REQUEST FOR INFORMATION **DATE:** July 06, 2016 **NO.:** RFI-191

Project Name: 15051-Webster University Interdisciplinary Science Building Project No.: 15051

Subject: Site Lighting

Refer to Sheet E0001 / Attached Drawings

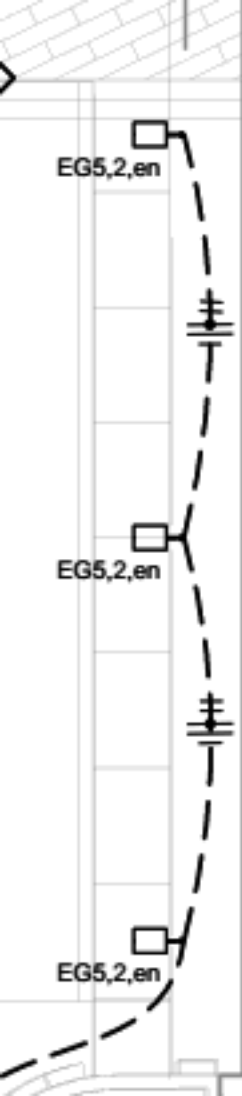
1. There are (3) fixture types EG which seem to be located above the 1st floor auditorium. Please advise how to secure these (3) fixtures. It seems a pole base wouldn't work in this area for these (3) fixtures.
2. Please provide dimensions for locating the type EE fixtures/ground fixture. We have (29) 2' Linear Ground Recessed Fixtures.
3. Please clarify the number of type EH stair fixtures... Should there be (8) fixtures or (9) fixtures?

1 - The three Type EG fixtures are intended to be located in the space between the auditorium and the EAB. This should allow the fixtures to be installed on standard concrete bases. Coordinate bases with other utilities.
2 - Coordinate the Type EE fixtures with the window mullions. On the north and south sections, the fixtures should be located 5' O.C. to match the window mullion spacing. On the west side, the fixtures should be located 4'-6" O.C. to match the window mullion spacing. The distance between the fixtures and the glass on the west side should be approximately 1'-6". On the north and south side, the fixtures should align with the edge of pavers, approximately 1'-2" from glass.
3 - There are nine fixtures shown on plans at the main stair. The fixture call out tag will be revised to reflect what is shown.
